METROPOLITAN AREA PLANNING
DEPARTMENT

Re: S/D 90-18 - WHITCHER ADDITION

STAFF REPORT
(Final Plat)

CASE NUMBER: S/D 90-18 - WHITCHER ADDITION

Note: This plat was submitted in final form only.

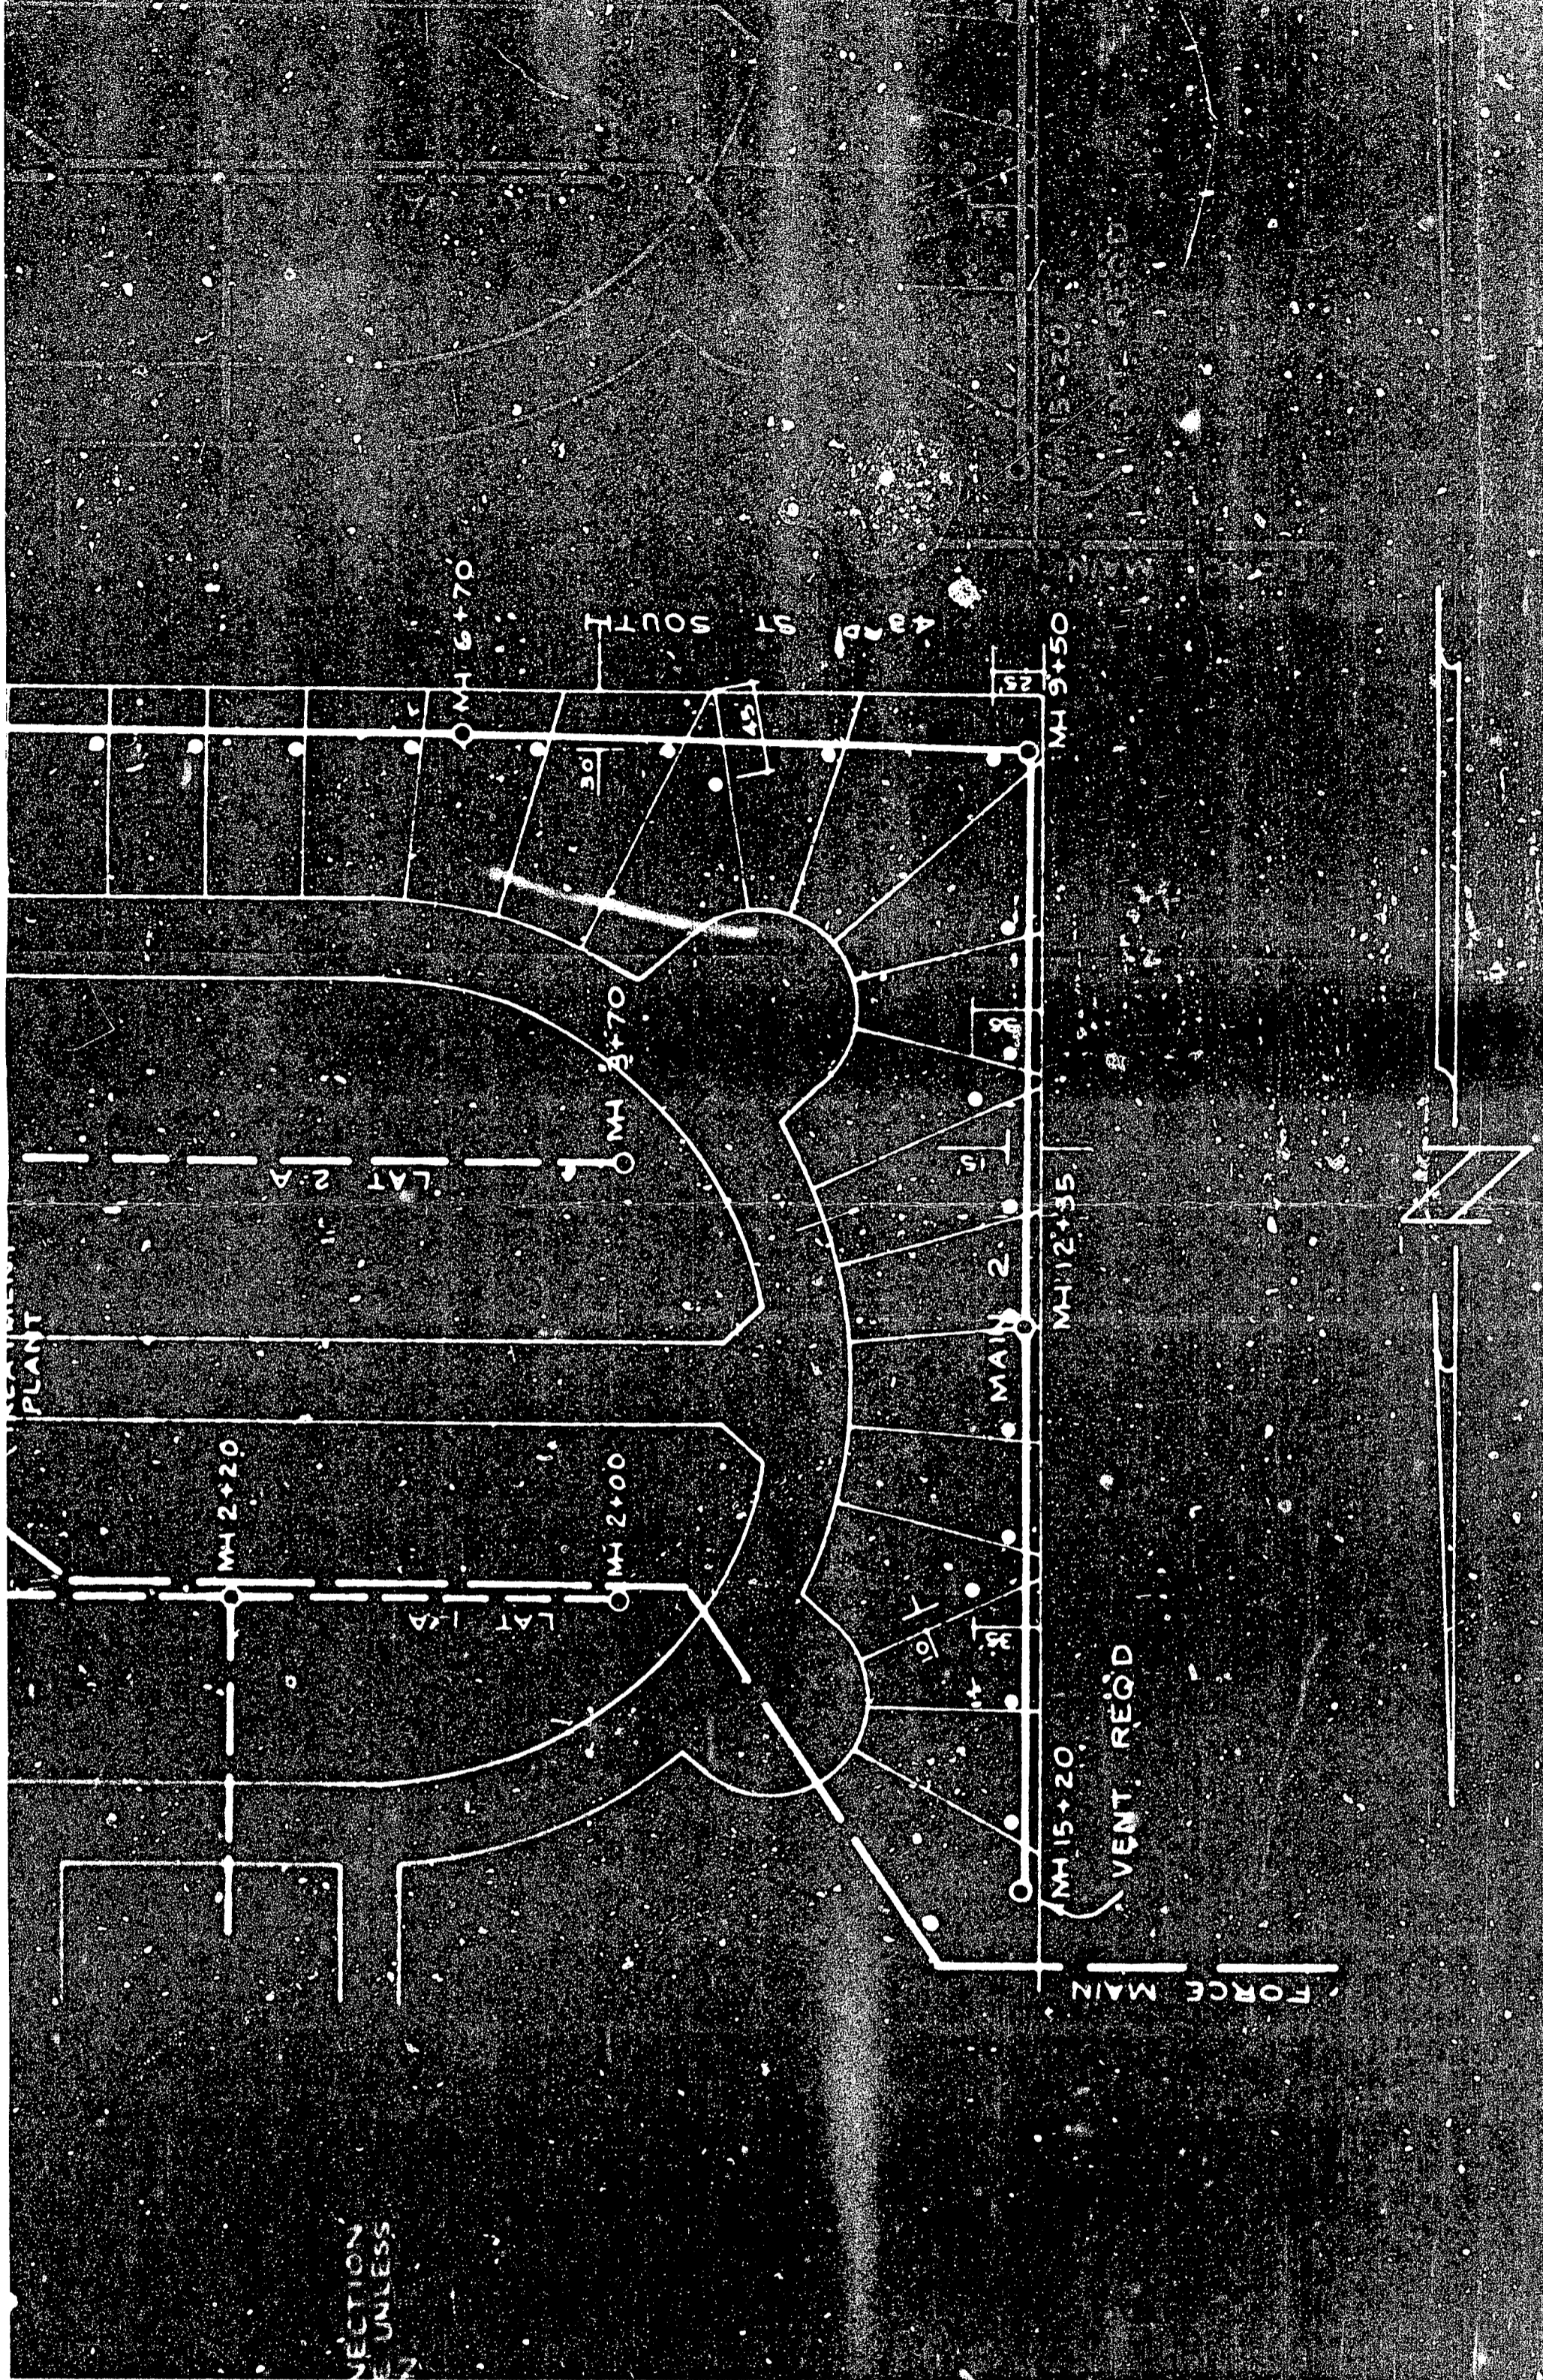
- A. The applicant shall guarantee the extension of sanitary sewer to serve Lots 1 & 2.
- B. The applicant shall guarantee any drainage improvements required by the platting of this property.

- D. The applicant shall submit, by separate instrument, a contingent street dedication for the north 30 feet of Lots 1 and 2 and the south 30 feet of Lots 3 and 4. The contingent street dedication shall be contingent upon all of the following conditions:

- E. The applicant shall submit a covenant that ties Lots 3 and 4 to Lots 1 and 2 in a combination that assures these lots will not be sold separate from a lot with direct access to 43rd Street South until such time that Horton Street is constructed. This covenant shall also state that no habitable structure may be constructed on Lots 3 and 4 until said Lots have access to sewer and water.

- F. On the final plat tracing the plattor's text shall cite the following: "The contingent street dedication as shown on the plat has been created by separate instrument."

- G. The sketch plat shows an oil well within the boundary of the plat. Therefore, the applicant's agent shall determine to what extent if any this plat is encumbered by any second party. The applicant is advised that a note may be required on the plat referencing any oil lease agreements.

- H. The applicant shall submit a copy of the "15 foot access easement," recorded on Film 470 and Page 228 to the Planning Department prior to this plat being scheduled for the City Council. Also, if this "access easement" is for private purposes the final plat tracing shall show it as a "private access easement."

- I. Approval of this plat will require a waiver of the lot depth to width ratio of the Subdivision Regulations. The Subdivision Regulations state that, "the maximum depth of all residential lots shall not exceed 2-1/2 times the width thereof."

- J. Since the tie point for this plat is referenced to a previously platted lot corner, the engineer's text shall reference the quarter section in which the plat is located. Section 5-402(D)(3).

- K. The applicant shall submit a copy of the K.G. & E. and Gas Service Easements prior to scheduling this plat for the City Council.
- L. The plattor's text misspelled "all" as "alld" this shall be corrected on the final plat tracing.

- M. Perimeter closure computations shall be submitted with the final plat tracing. Section 5-101(c).
- N. Recording of the plat within 30 days after approval by the City Council.

- O. The applicant's engineer is advised that the Register of Deeds is requiring the name(s) of the notary public, who acknowledges the signatures on this plat, to be printed beneath the notary's signature.

- P. The representatives from the utility companies should be prepared to comment on the need for utility easements to be platted on this property.
- Q. The representative from the City Engineer's office should be prepared to comment on the status of the applicant's drainage plan.
